RE: Homestake Mining Company of California
– License SUA-1471
Grants Reclamation Project
Responses to NRC Request for Additional Information (RAI) dated 6/13/07

HOMESTAKE MINING COMPANY RESPONSES TO
Request for Additional Information, Homestake Mining Company,
Grants Reclamation Project
From the Nuclear Regulatory Commission

**SUBJECT: RESPONSE TO NRC REQUEST FOR ADDITIONAL
INFORMATION, COMMENT #2 REGARDING EMBANKMENT SLOPE
STABILITY OF EP3 EMBANKMENT**

Homestake Evaporation Pond Number 3: Response to NRC Request for Additional Information Comment No. 2

Figure 10. Static Analysis: Phreatic Surface 3, Corrected Janbu Method

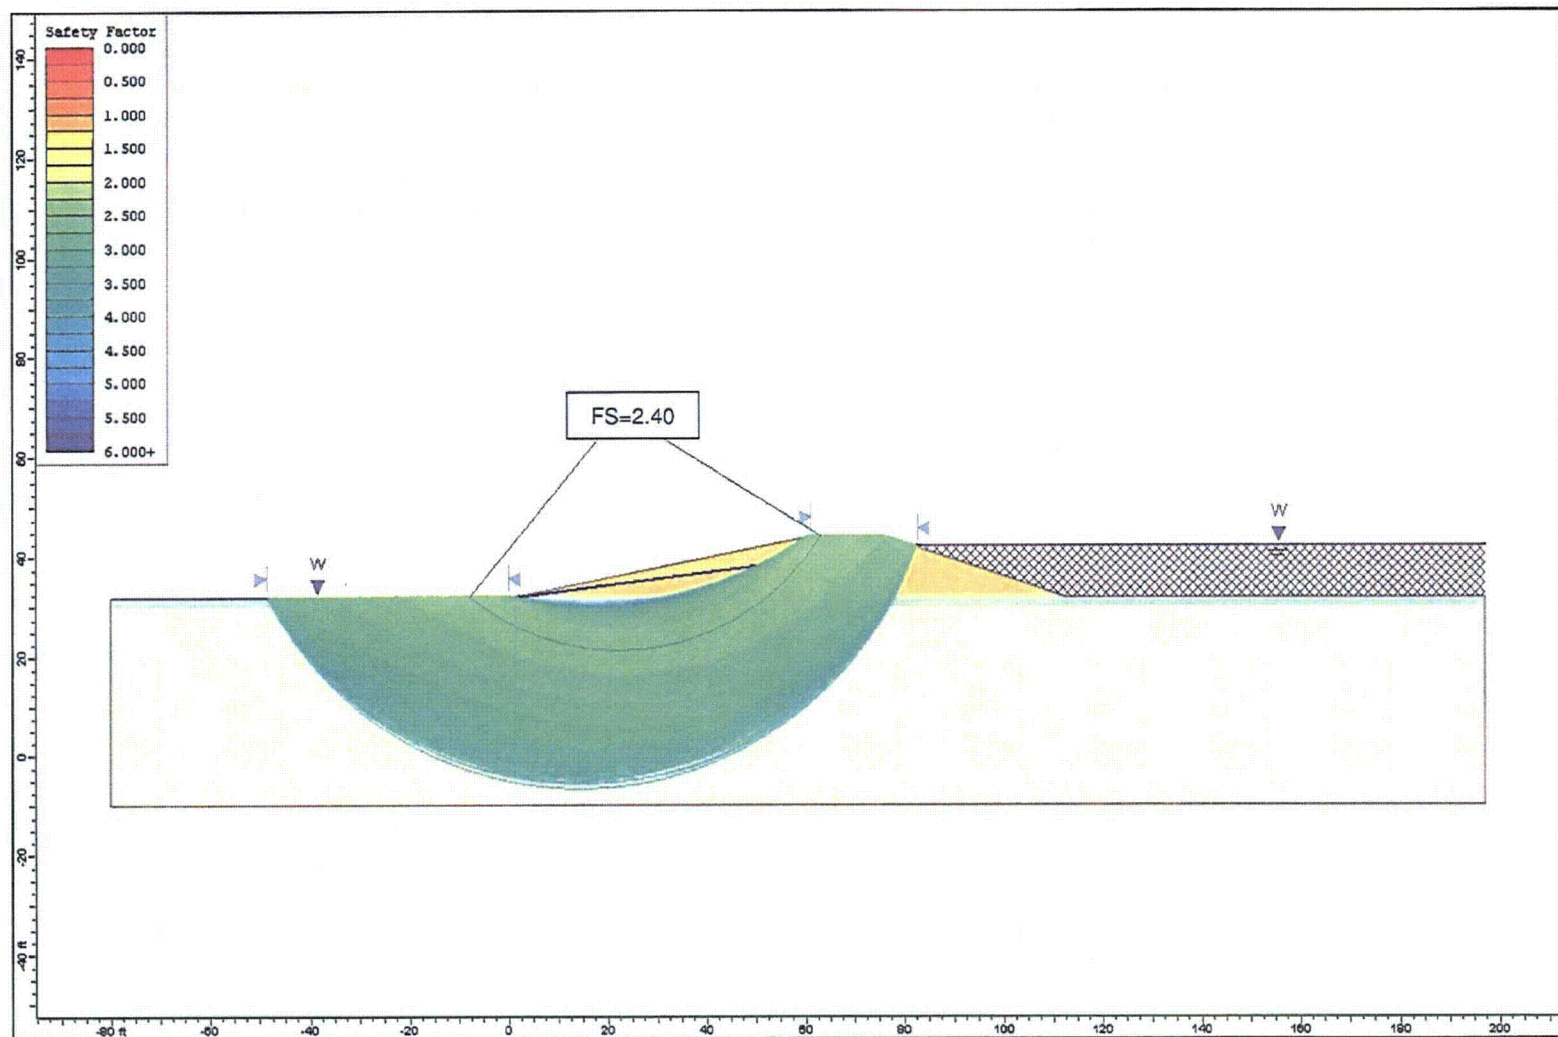
Discussion: A stability analysis should be prepared for the perimeter embankment for the critical cross section. The critical cross-section is likely to be where the embankment fill placed is the greatest. However, HMC will need to provide a basis for selection of whatever critical cross-section it analyzes. The stability analysis also should include a pseudo-static analysis to account for seismic loading. In addition, discuss why liquefaction is not a concern for this design.

completely saturated embankment. The second phreatic surface represents a water level equal to the maximum allowable water height, namely, a freeboard of 2 feet with saturation extending to the slope. The third scenario also represents a freeboard height of 2 feet but has the phreatic surface extending to the outslope toe. A minimum factor of safety for each scenario was determined using SLIDE. Results of the static slope stability analysis are presented in Table 2 and Figures 5 through 10 and figure 17.

Phreatic Surface	Minimum Factor of Safety Simplified Bishop Method	Minimum Factor of Safety Corrected Janbu Method
1	2.02	1.96
2	2.08	2.04
3	2.46	2.40
1 (fully saturated, no cohesion)	1.42	1.41
